# JDC RANCH

A MASTER PLANNED COMMUNITY

**STANDARD STREET SECTION**

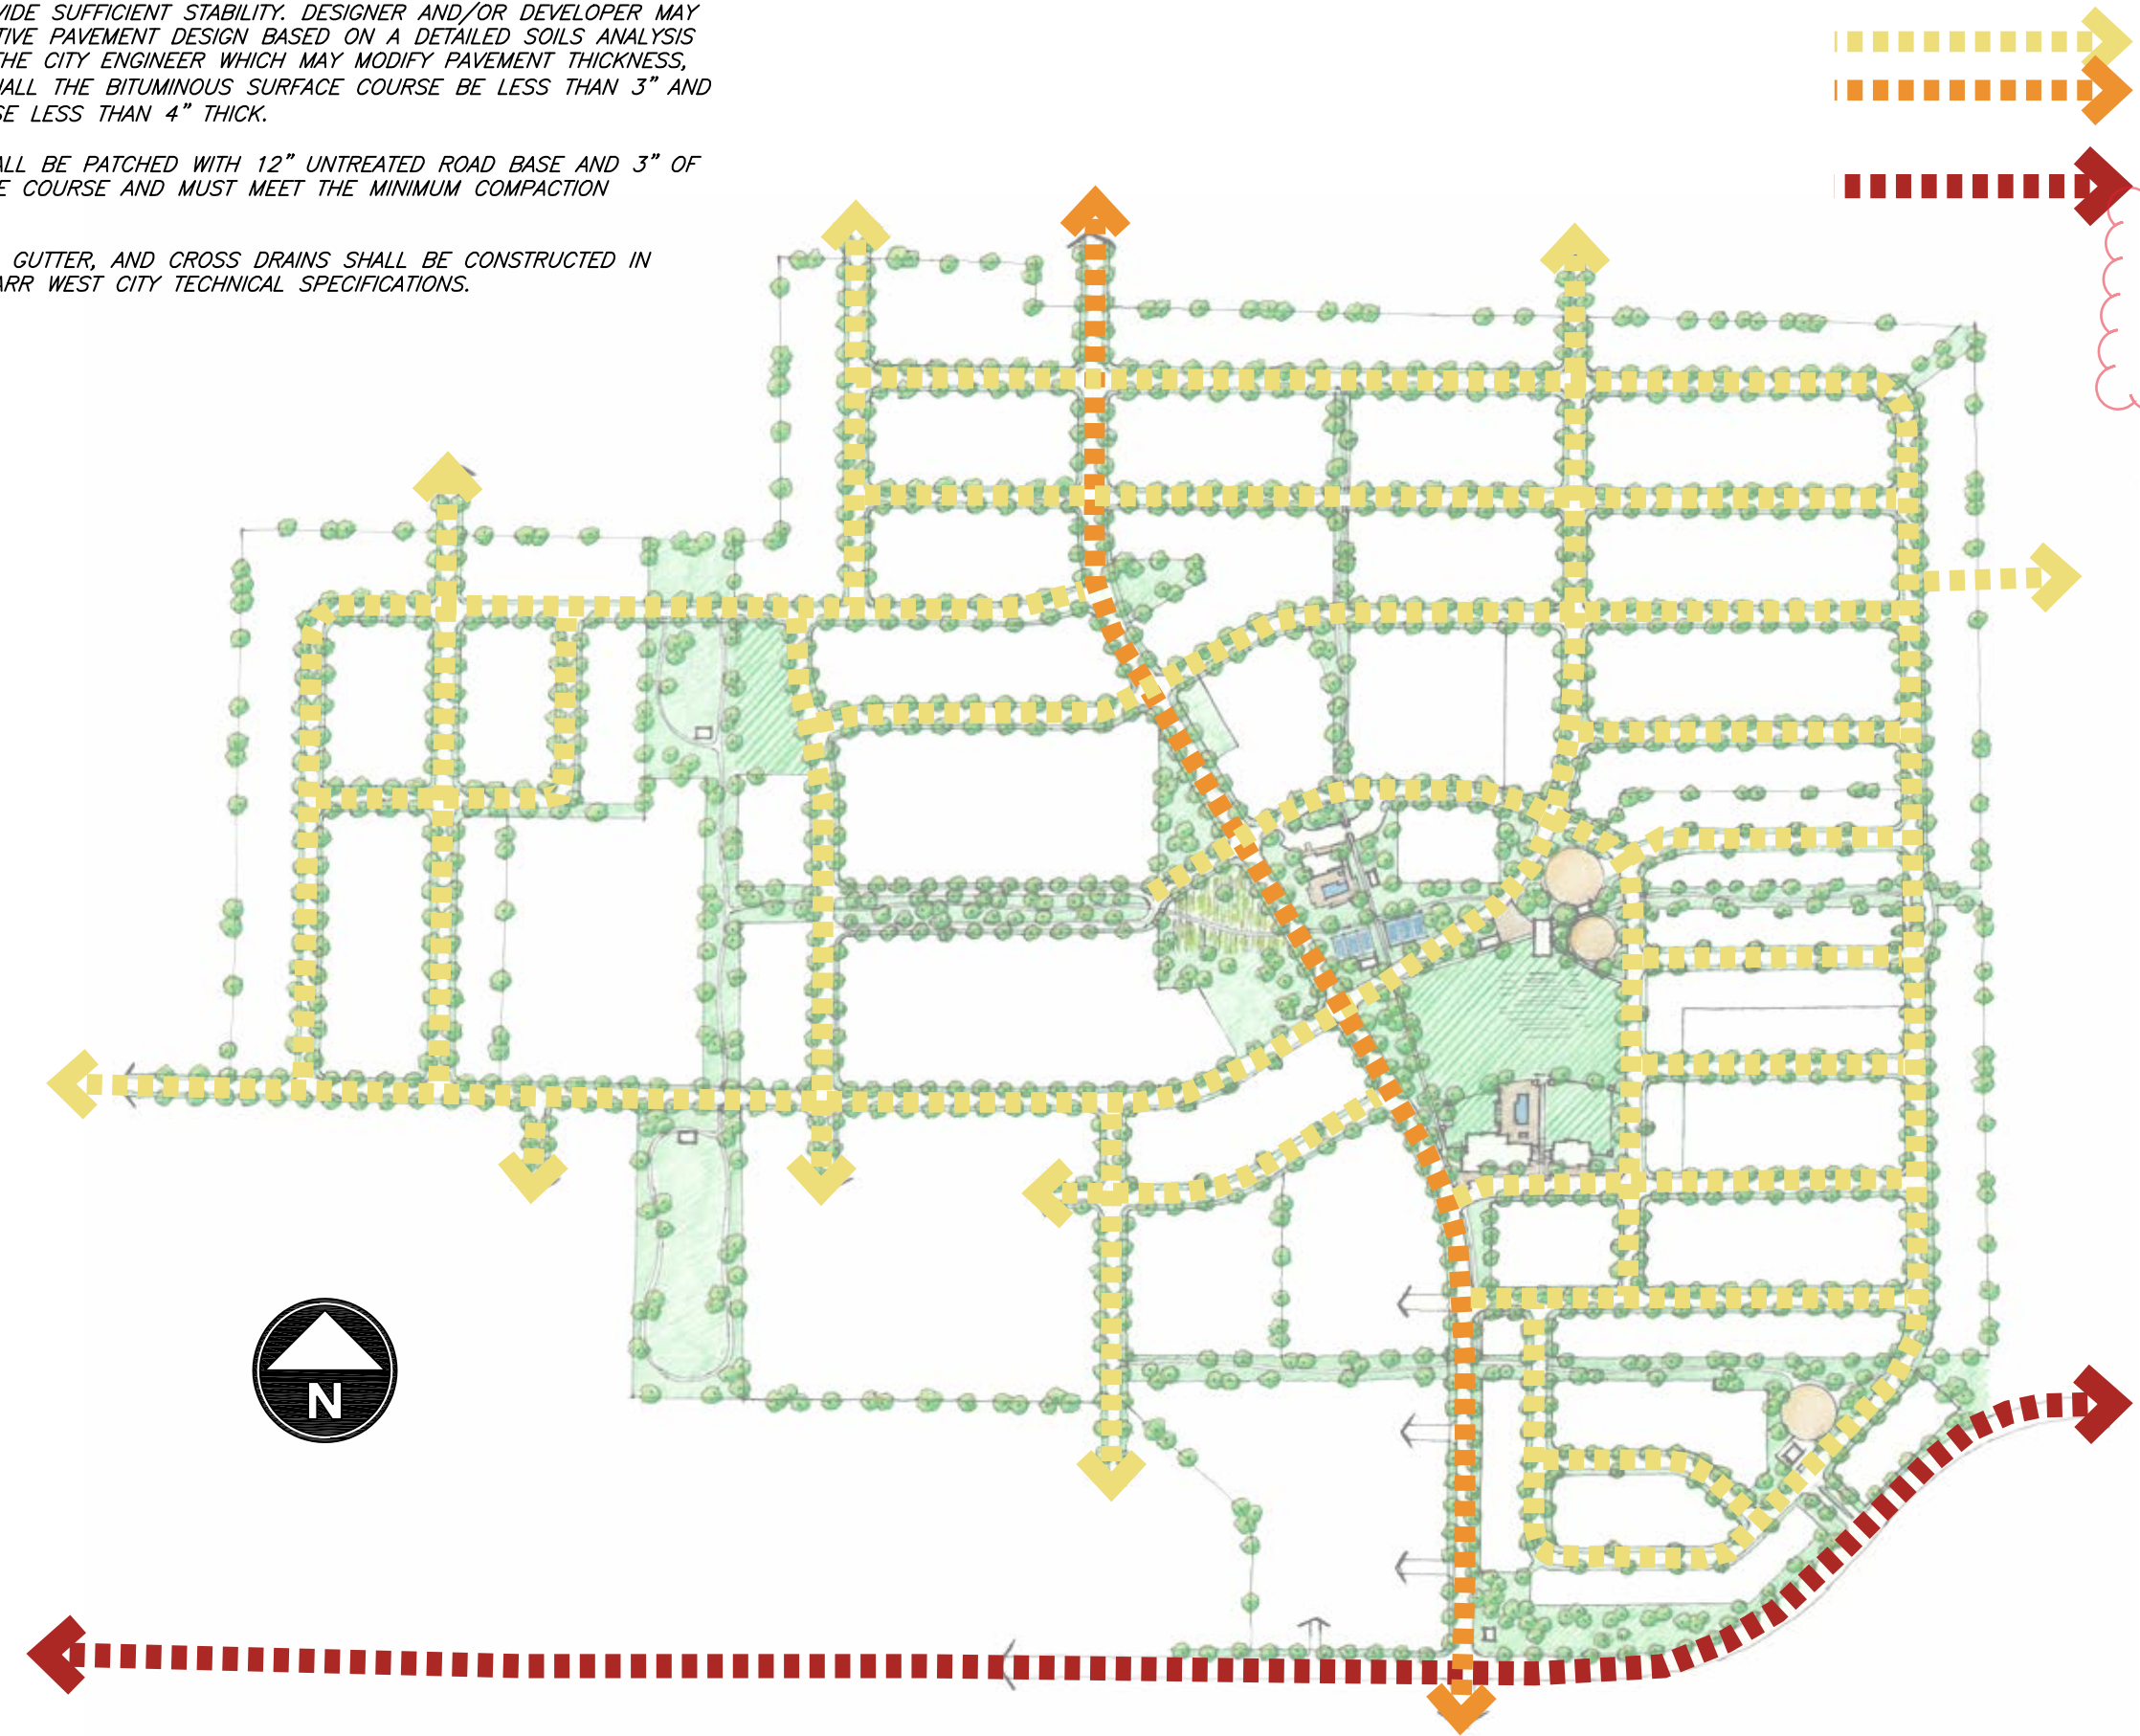
Is the intention of this page to get vested into a specific set of ROW standards?
